**File #:** PC Reso 04-2017  
**Name:**  
**Type:** PC Resolution  
**Status:** Public Hearing  
**File created:** 4/11/2017  
**In control:** Planning Commission  
**On agenda:** 4/26/2017  
**Final action:** 4/26/2017  
**Title:** Resolution to approve a planned development overlay for 5530 South Curtice Street.

**Project Name:** Curtice Street Duplex

**Application Type:** Planned Development Overlay

**Project Description:** Proposal for a residential duplex on one lot with variations to setback and height standards in the R-5 zone.

**Figure 3.**  
**Context for the proposed 16-foot front setback, from the PDO plan set.**

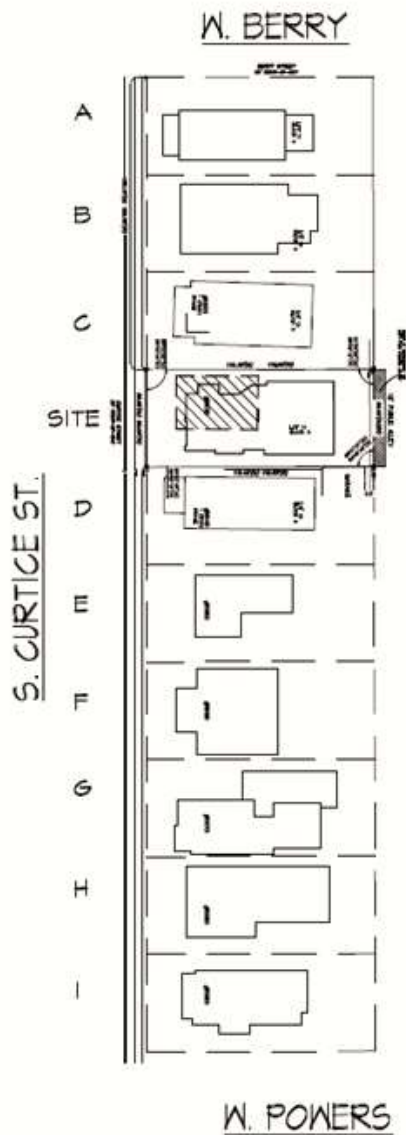
The applicant has provided an analysis of how the proposed setback and height variations are consistent with the existing land use characteristics of the district. (please refer to attached Letter of Intent). In the letter, the applicant states that the proposed modifications would not have a detrimental effect on the character of the neighborhood. With respect to the front setback, the proposed 16-ft. setback appropriate in that it is consistent with the predominant front setback for the block face, which has an average of 15.95-foot front setback, as shown in figure 3. The applicant states that the reduced side setback for the south lot is consistent with the existing character of the block as other homes have narrow side yard setbacks. With respect to height, the applicant states that the proposed 31-ft. tall building, which is 1-ft. greater than the allowable 30-ft. height, will not have a significant visual impact within the neighborhood.

Staff concurs with the applicant's analysis of the proposed setback and height variations with respect to the development pattern in the R-5 district. Further, the development is a benefit to the city: its proposed architectural design is of high quality, utilizing building materials and architectural features that are commonplace on South Curtice Street; the architectural style is based on the craftsman style, which will be complementary to the older homes within the neighborhood, helping to preserving its character; and it provides a new construction option to the neighborhood. Further, the duplex would not impair the intent of the land used code, which allows both single family and multifamily development in the R-5 zone.
